# ADA Curb Ramp New Construction Inspection Form (Perpendicular)

NW 209th

24952.54

NW King

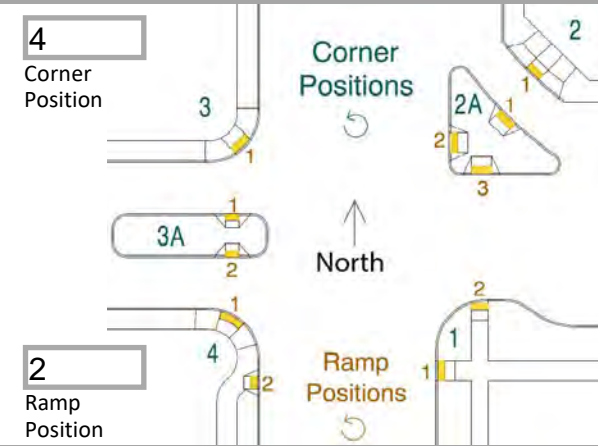
RR1 ICRR, RO Vertical Drop
